**Committee of Experts on the Transport of Dangerous Goods  
and on the Globally Harmonized System of Classification  
and Labelling of Chemicals**

**Comments on documents ST/SG/AC.10/C.3/2022/50 –  
ST/SG/AC.10/C.4/2022/10 and informal documents INF.20  
(TDG) – INF.12 (GHS): Classification of desensitized  
explosives according to the GHS**

**Transmitted by the expert from the United Kingdom**

*Decision logic 2.17.1 for desensitized explosives*

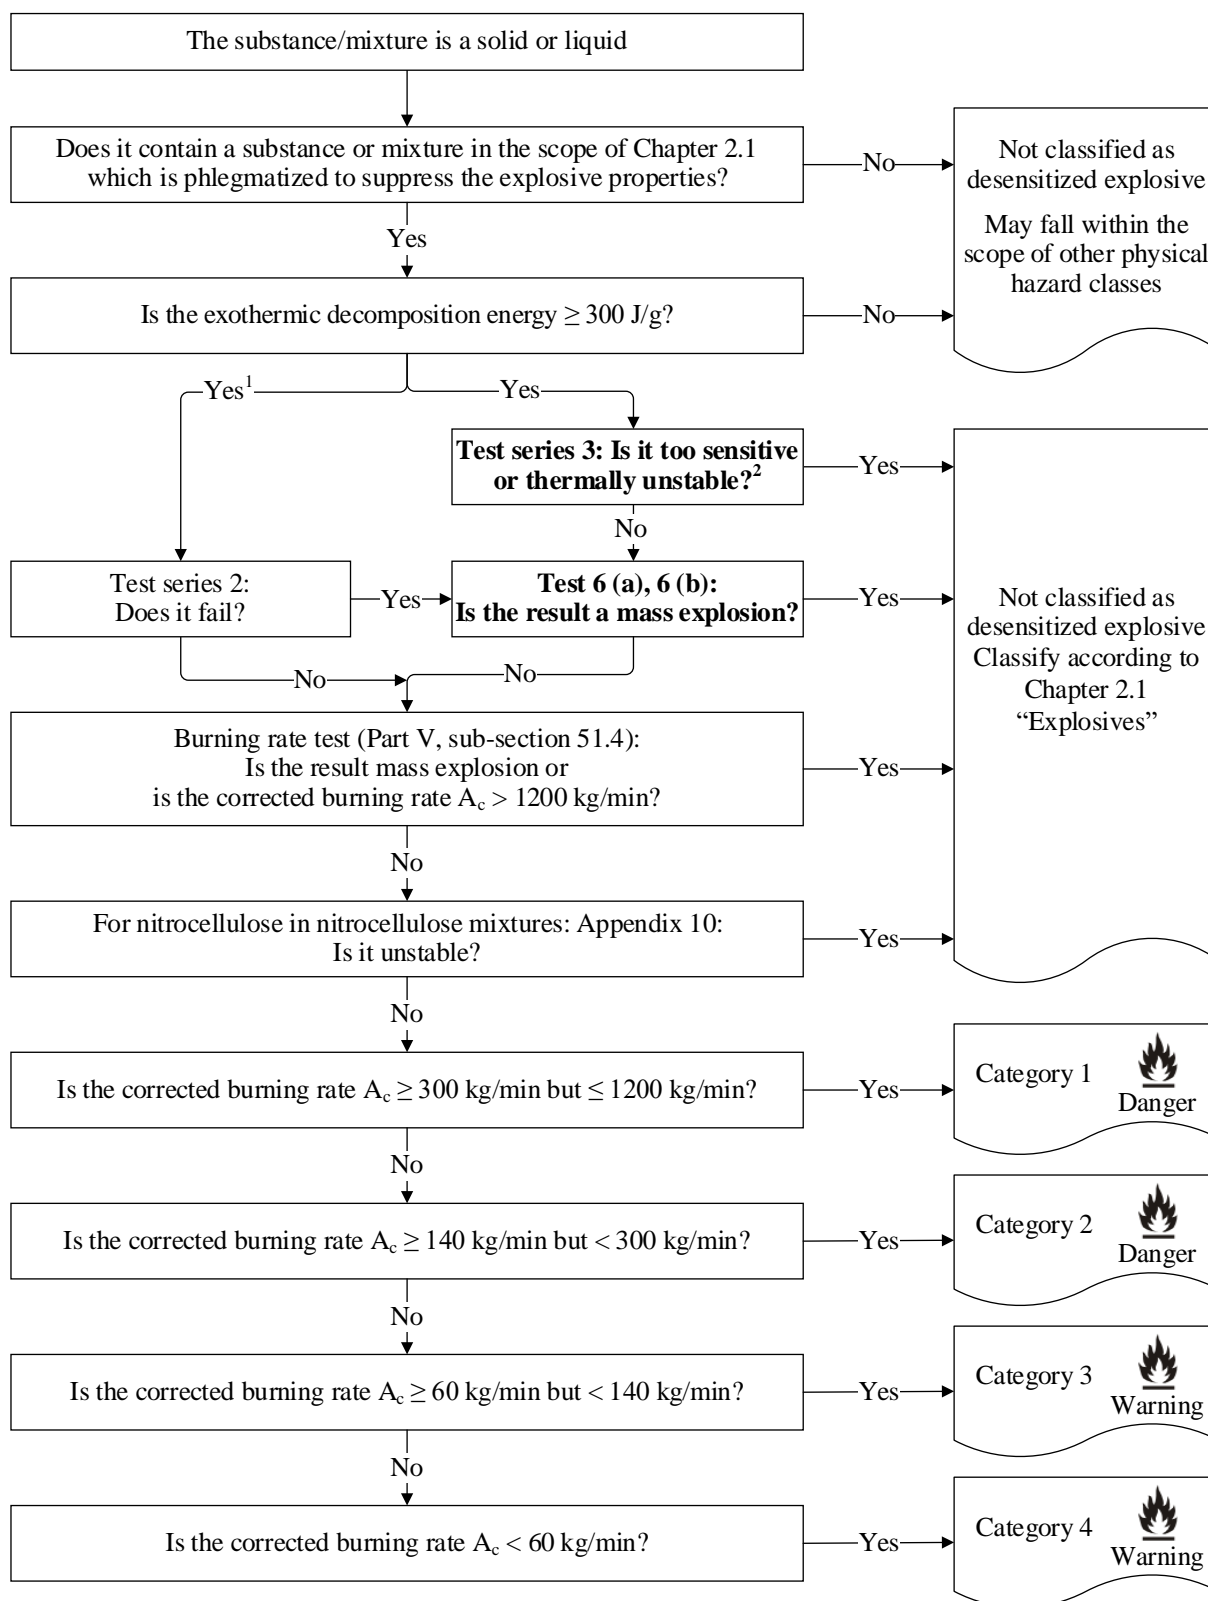
[Amend footnote 2 to decision logic 2.17.1 as follows:

“<sup>2</sup> Test 3 (c) is not applicable to nitrocellulose mixtures containing no explosives other than nitrocellulose.”]

<sup>2</sup> Test 3 (c) is not applicable to nitrocellulose mixtures containing no **other** explosives **other** than nitrocellulose.
